Subject: Response to Request for Additional Information
Proposed Changes to Technical Specifications
Safety Limit Minimum Critical Power Ratio
Cooper Nuclear Station, NRC Docket No. 50-298, DPR-46

**GLOBAL NUCLEAR FUEL DOCUMENT ENTITLED
"RESPONSE TO NRC REQUEST FOR ADDITIONAL
INFORMATION-COOPER CYCLE 20-MARCH 14, 2000"**

Response to NRC Request for Additional Information – Cooper Cycle 20 – March 14, 2000

Figure 1 Reference Core Loading Pattern

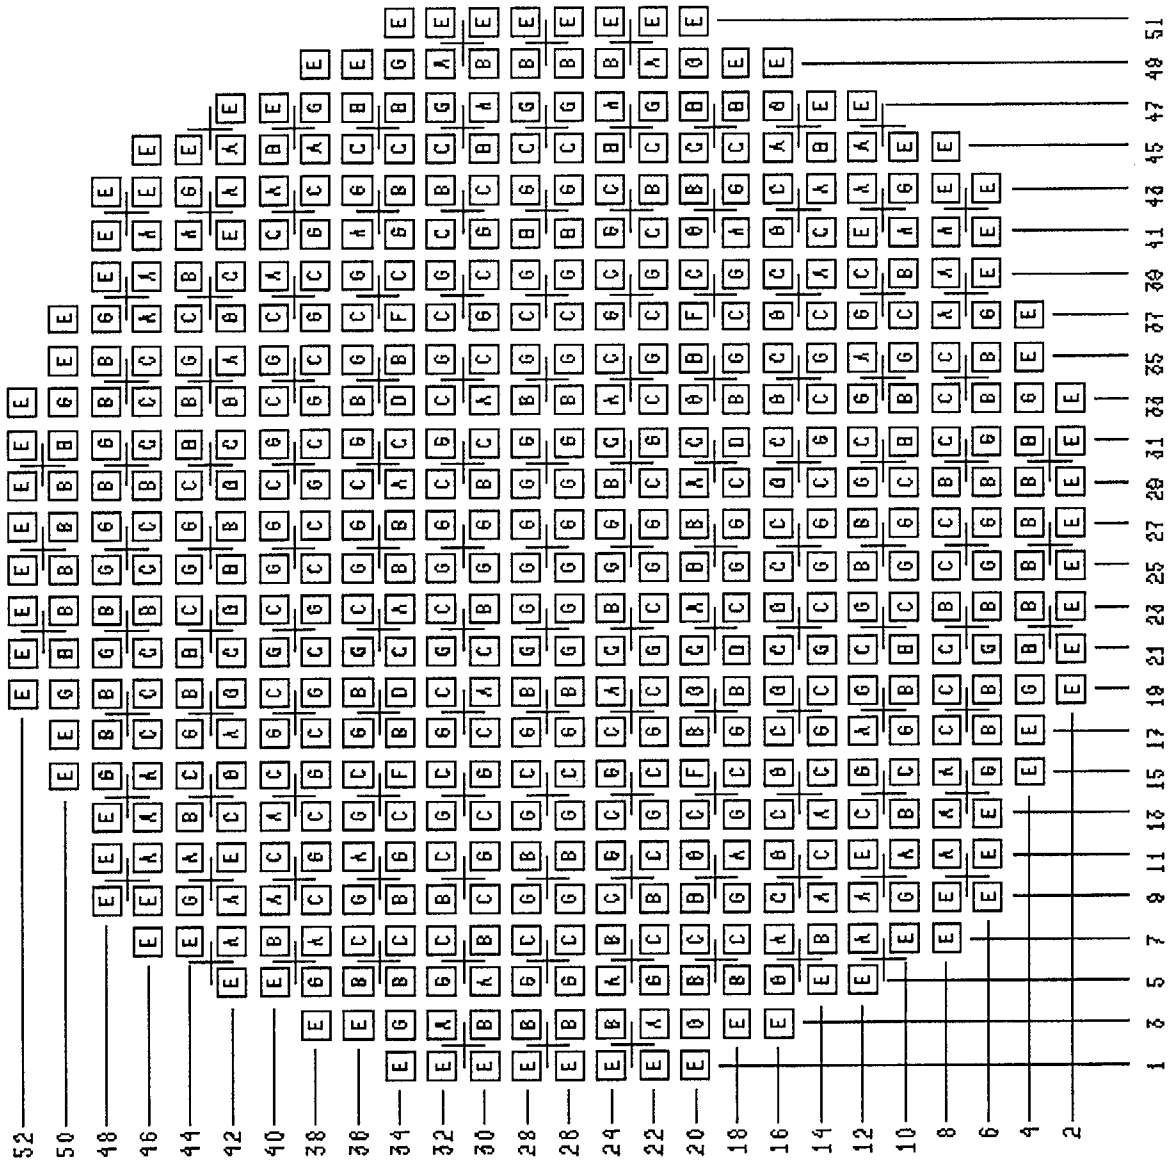
1. Provide the fuel types and numbers of assemblies used in Cooper Cycle 20 operation and identify if they are fresh or irradiated fuel (once or twice burned, etc.). Also, provide the fuel loading pattern for Cycle 20 and identify its difference from Cycle 19 and the impact on the SLMCPR calculation.

The requested core loading information is available in the Supplemental Reload Licensing Report (SRLR) for Cycle 20 (J11-03650-10, Rev. 0, Supplemental Reload Licensing Report for Cooper Nuclear Station Reload 19 Cycle 20) and provided as Attachment 1. Equivalent information is supplied in the SRLR for Cycle 19 (J11-03354-10, Rev. 0, Supplemental Reload Licensing Report for Cooper Nuclear Station Reload 18 Cycle 19) provided as Attachment 2. The impact of the fuel loading pattern differences on the calculated SLMCPR is correlated to the values of MIP (MCPR Importance Parameter) and RIP (R factor Importance Parameter). The [[]] values for both cycles are provided in Appendix A, Table 1 of the December 6, 1999 submittal (Update to Appendix A, Table 1 of the December 6, 1999 submittal is Attachment 3).
